Prestonpans to Levenhall active travel improvements

Response from Spokes Planning Group, November 2025

Figure 3.11: Cycle track at footway level (separated from pedestrians)

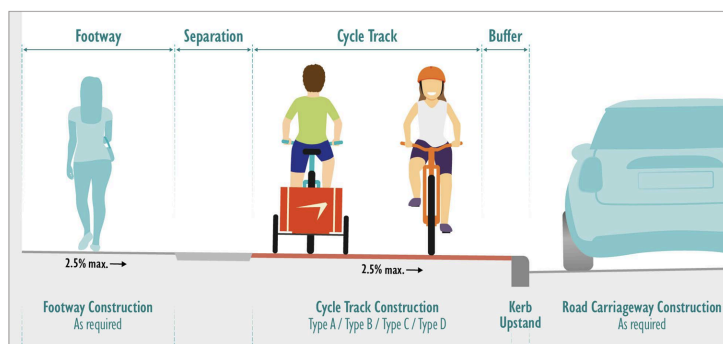
The 4m wide shared use path with 1m buffer proposed is as per Cycling by Design 2021 guidance. This shared use section of path seem to vary in width from 2.5m to 4.5m meaning at points it is below the 4m¹ recommended in Cycling by Design 2021. This also states shared use is best where there will be “*low speed differential between users, often established by a high degree of non-linear movement, a high place function or high degree of leisure or other slow speed movement which influences the behaviour of users.*” However given limited destinations on this linear route **segregation rather than a shared path** would be better for all users.

The diagram adjacent is taken from p77 of *Cycling By Design 2021*. Given the nature of the route between two large urban areas with leisure destinations along the route it seems appropriate some separation will be preferable along the whole length.
